STAFF REPORT
COMMUNITY DEVELOPMENT DEPARTMENT

HEARING DATE: 07/28/2026

SUBJECT: Dayspring Subdivision No. 4
FP-2026-0016

Final plat consisting of 29 buildable lots and 8 common lots on 4.64 acres of land in the TN-R zoning district for the fourth phase of Dayspring Subdivision.

C. Landscape Plan (dated: 5/28/2026)

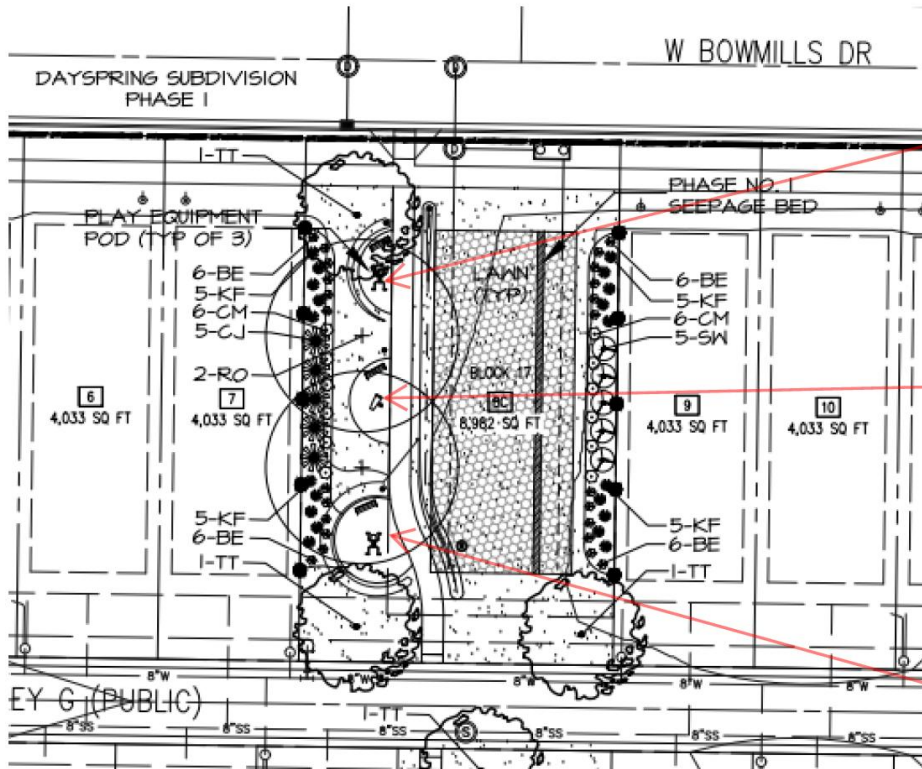
5. The landscape plan prepared by Jensen Belts Associates, dated 5/28/2026, included in Section V.C, shall be revised as follows:
 - i. Include the required number of (residential lot) street trees in the Landscape Calculations table for the parkway strips along local streets that were counted toward qualified open space that demonstrates compliance with the standards listed in UDC 11-3B-7C.3.
 - ii. Include the tree classifications in the Plant Schedule table that demonstrates compliance with the standards listed in UDC 11-3B-7C.3b and 11-3B-12C.7.
 - iii. Include the required vs. proposed number of trees along pathways, including linear feet of pathways, in the Landscape Calculations table that demonstrates compliance with the standards listed in UDC 11-3B-12C.

1. Provided landscaping plan does not match up with civil plans. Applicant to provide an updated landscaping plan that matches the civil layout with the RSUB record. Ensure that no trees or deep-rooted bushes are within easements or within 5' for fire hydrants or water meters.
